City of Richmond

Report to Committee

To:	General Purposes Committee	Date:	May 24, 2016
From:	Phyllis L. Carlyle General Manager, Law and Community Safety	File:	12-8350-05-AMANDA #/Vol 01
Re:	Non-Farm Use Fill Application by Sixwest Holdings Ltd. No. BC1025692 for Property Located at 14791 Westminster Highway

***RE: Response to McTavish Resource & Management Consultants Ltd. Assessment of
'Non-Farm use fill application' at 14791 Westminster Hwy, Richmond***

FIGURE 1

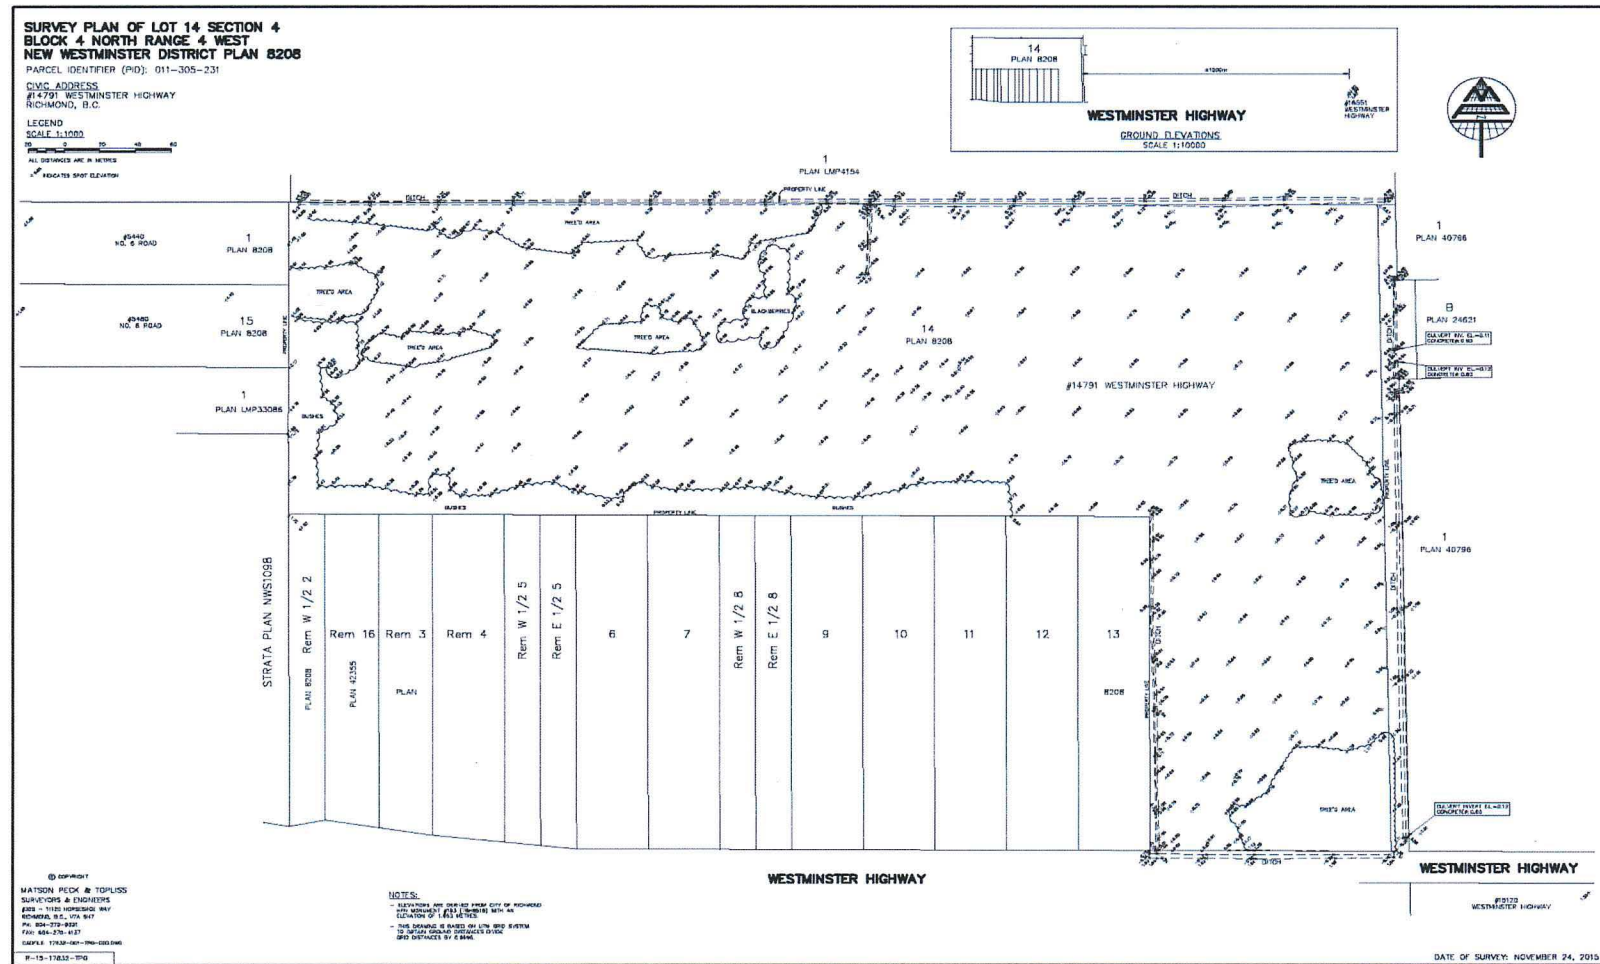
1 A detailed topographic survey referenced to geodetic datum.

This has been completed. See Figure 1.

The survey confirms that the ground is at a low elevation, relative to adjacent properties. The BCLS surveyor confirms that the average elevation of the property is 0.6 m, which is low for Richmond. Other off-site elevations were measured, as follows:

Figure 1 shows that about 70% of the land area lies between 0.5 and 0.7 m elevation. The remaining 30% - mainly in the western portion – lies below 0.5 m.

FIGURE 2A

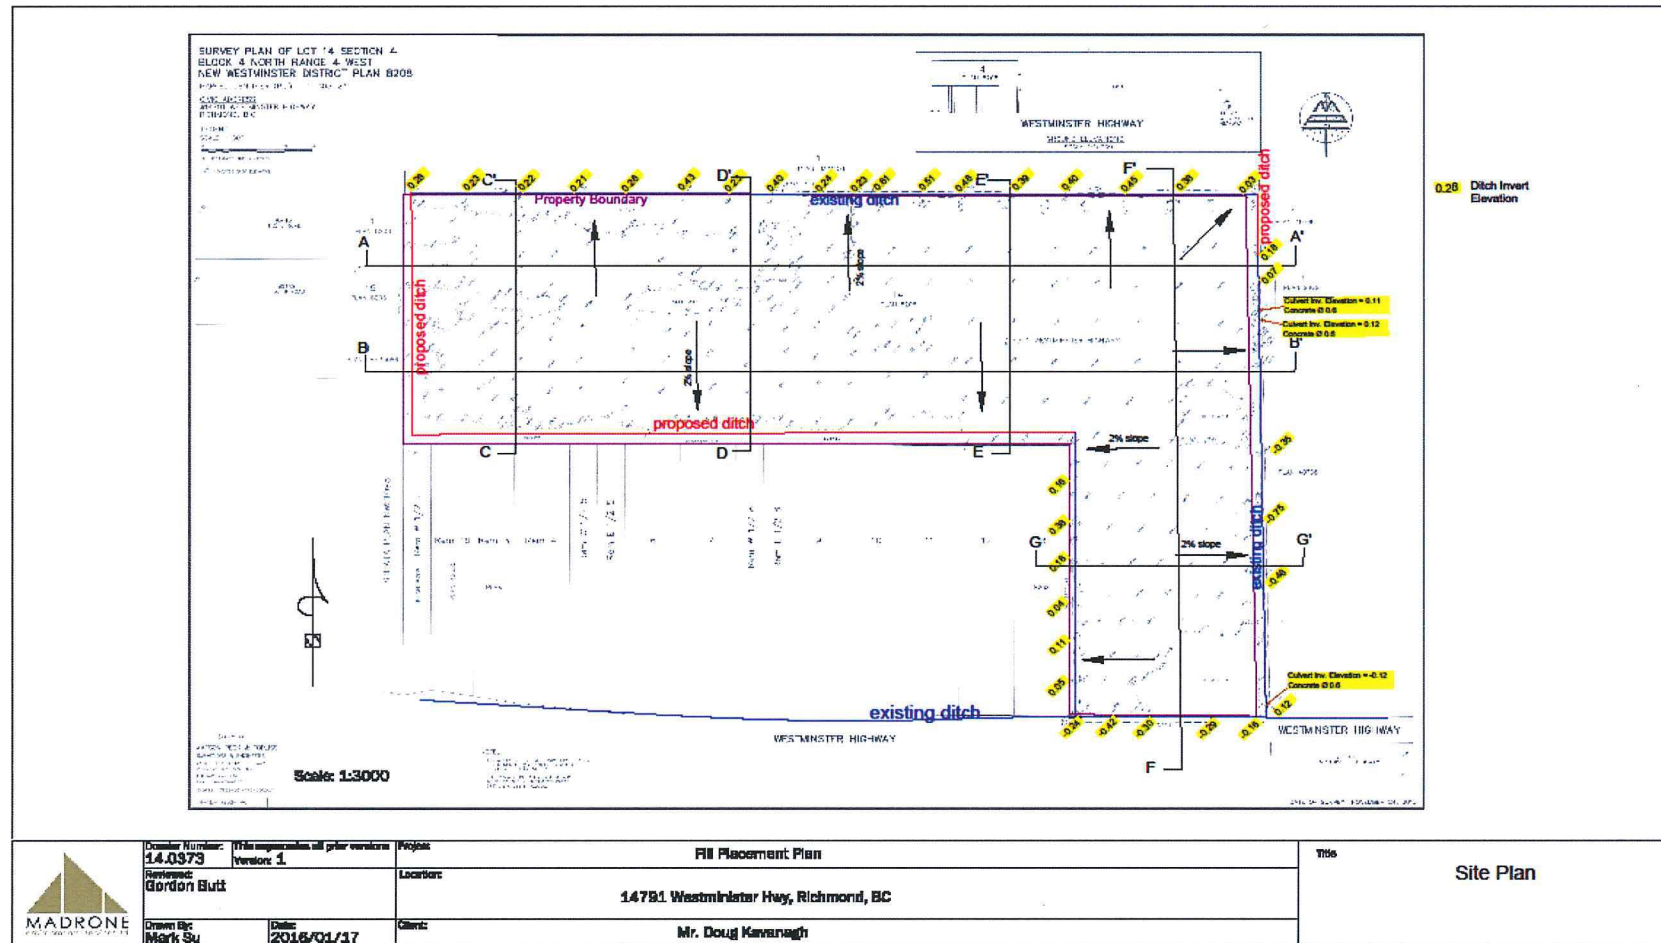
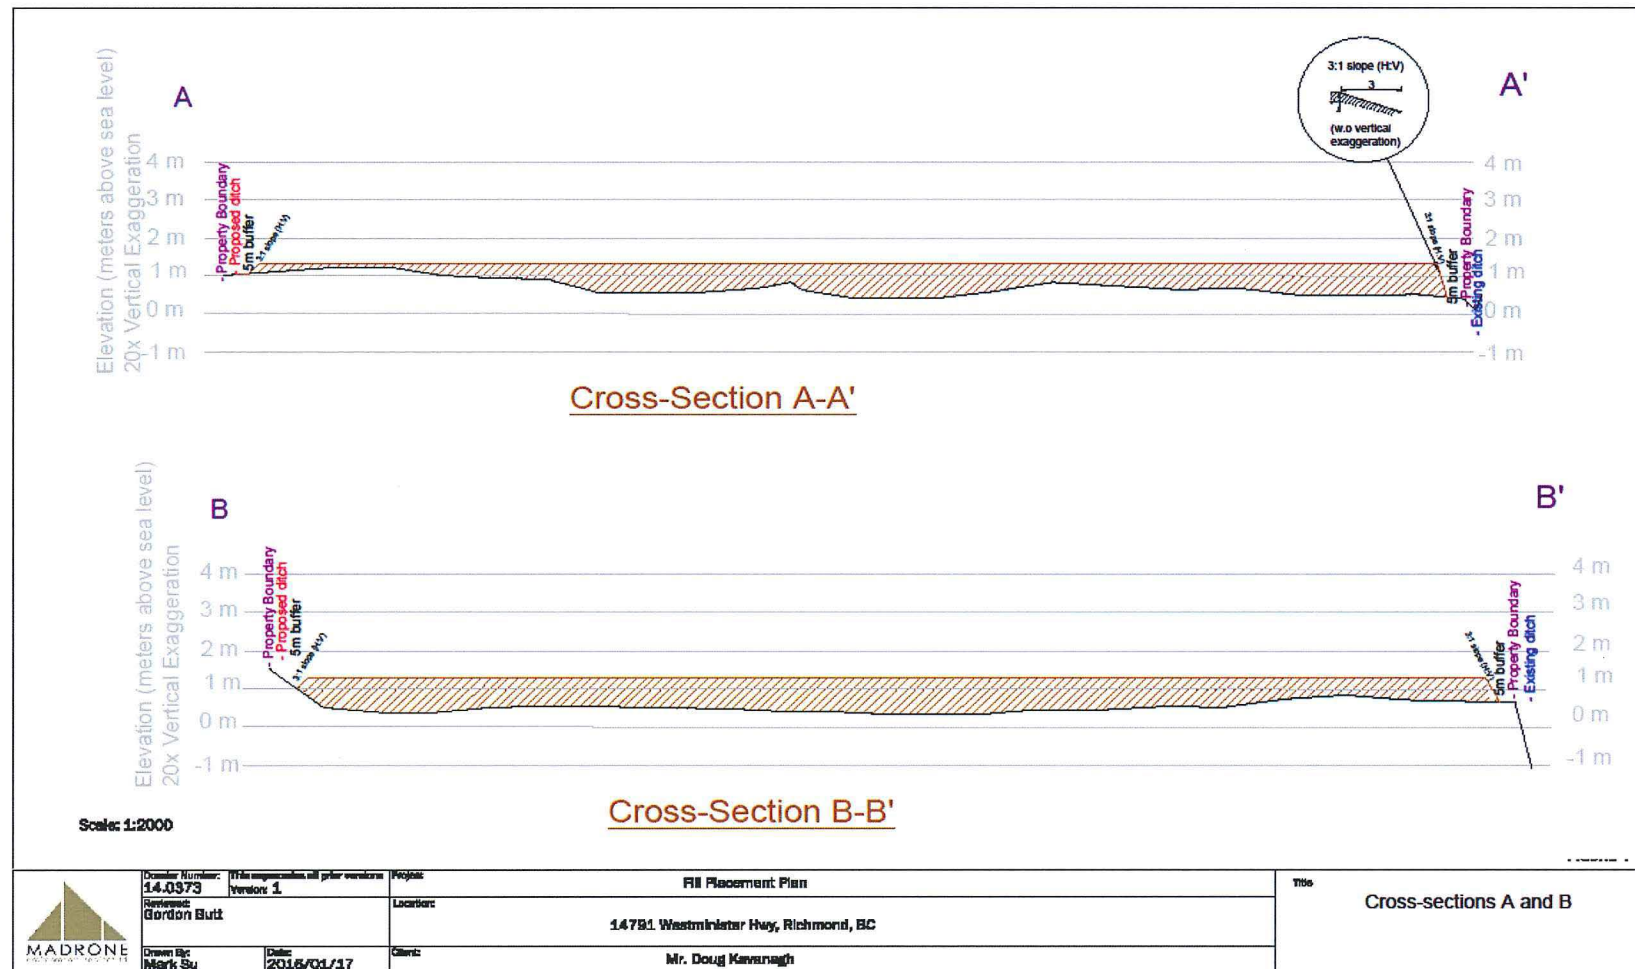
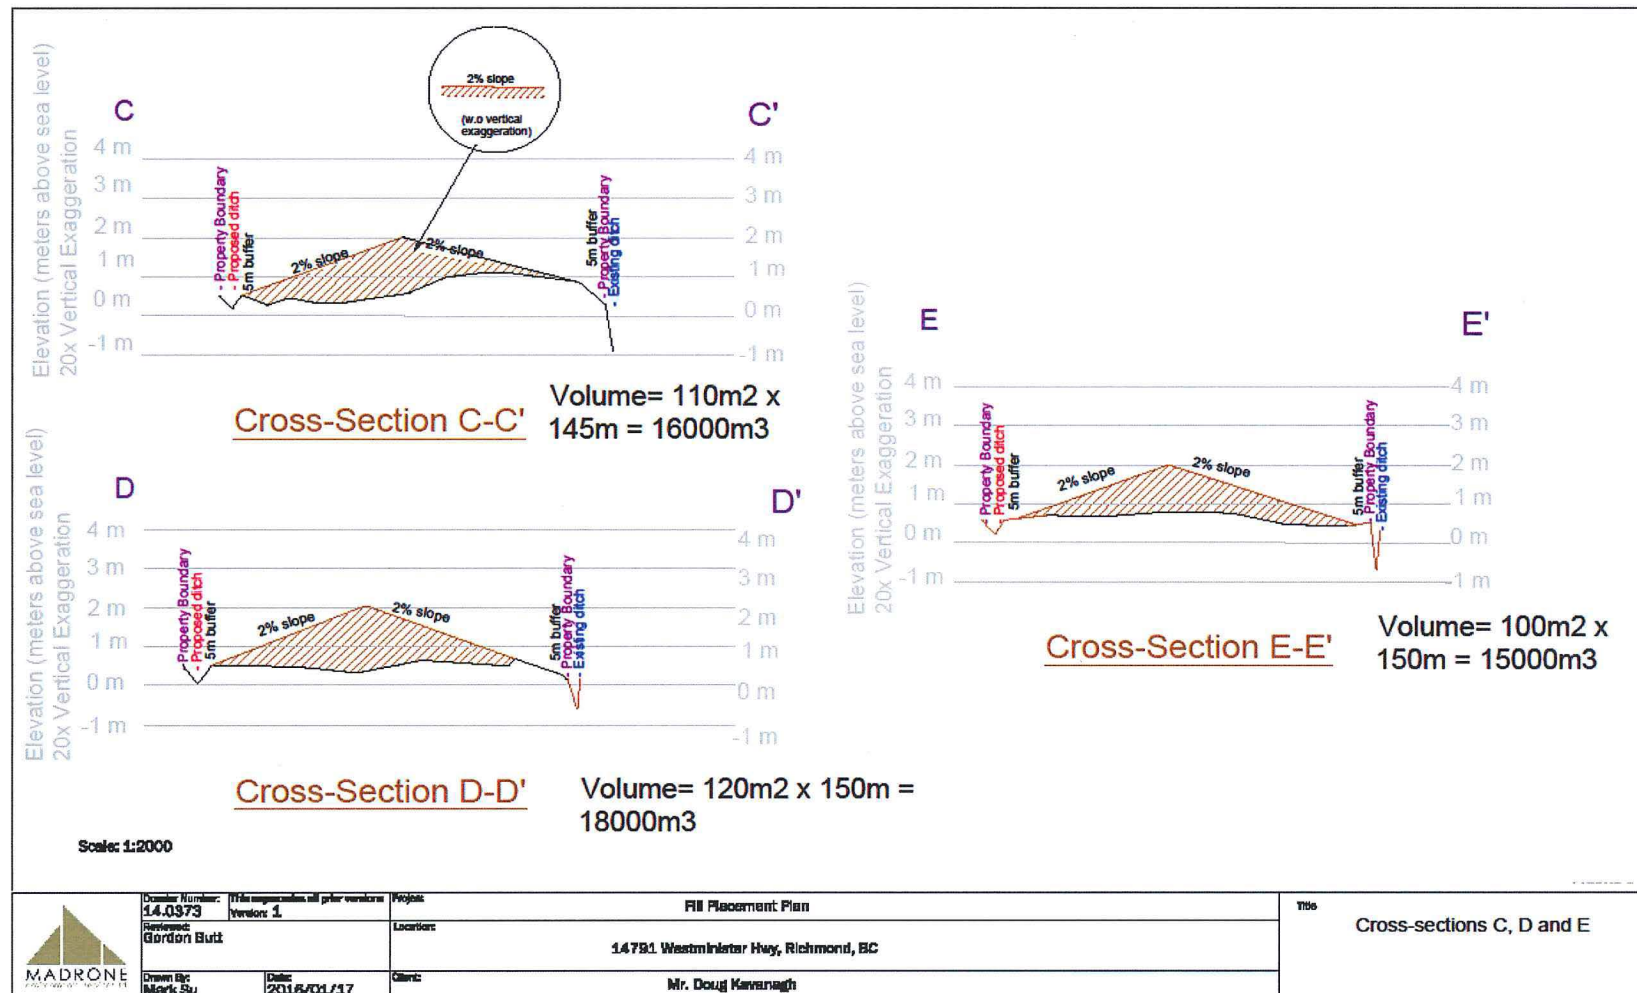
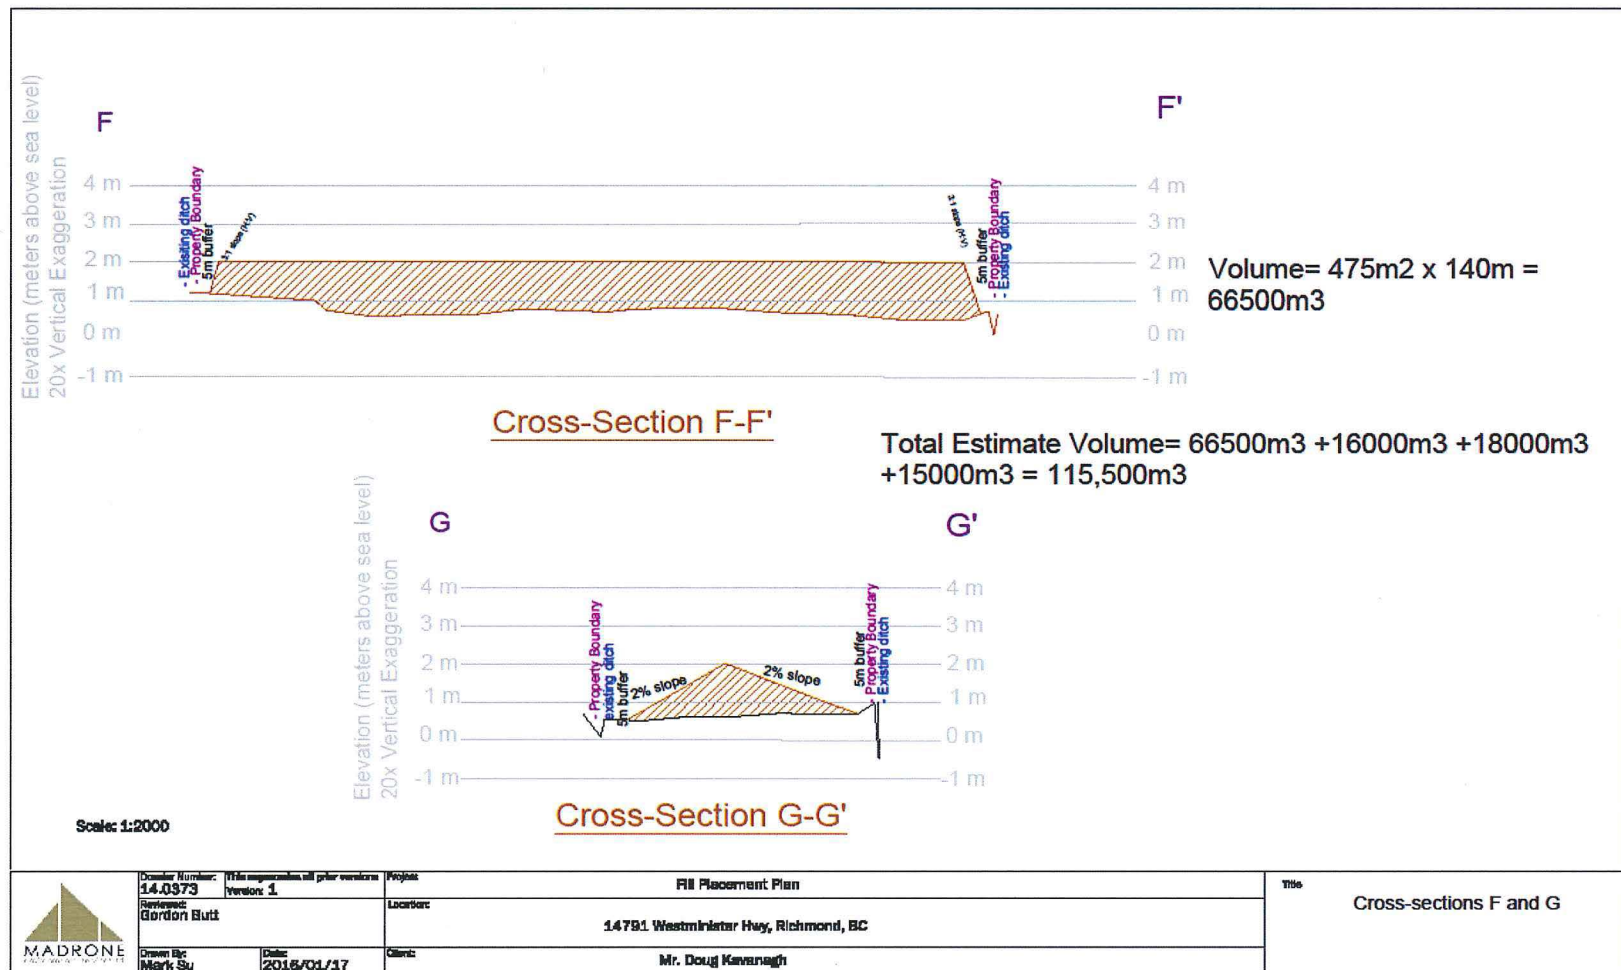
2 Elevations and cross-sections showing the finished grades with topographic reference to geodetic elevations.

5 A detailed drainage plan including the invert levels of all drainage pipes;

See Figure 2a, b, c and d. These cross-sections are a more detailed version of a similar diagram that was included in the original submission. It shows the topographic variation in the ground surface, as provided by the detailed geodetic survey. The slope away from the centre has been increased to 2% to allow better drainage towards the periphery.

Figure 2a shows existing and proposed ditches on the subject site. An existing ditch runs the length of the northern boundary. Invert elevations range from 0.61 to 0.03 (in the northeastern corner).

Figure 2a shows the location of existing and proposed ditches. Figures 2b through 2d show cross-sections of the proposed fill. No in-field drainage is planned; however, the fill will be graded to 2% grades from a central east-west ridge to allow for drainage to adjacent ditches.
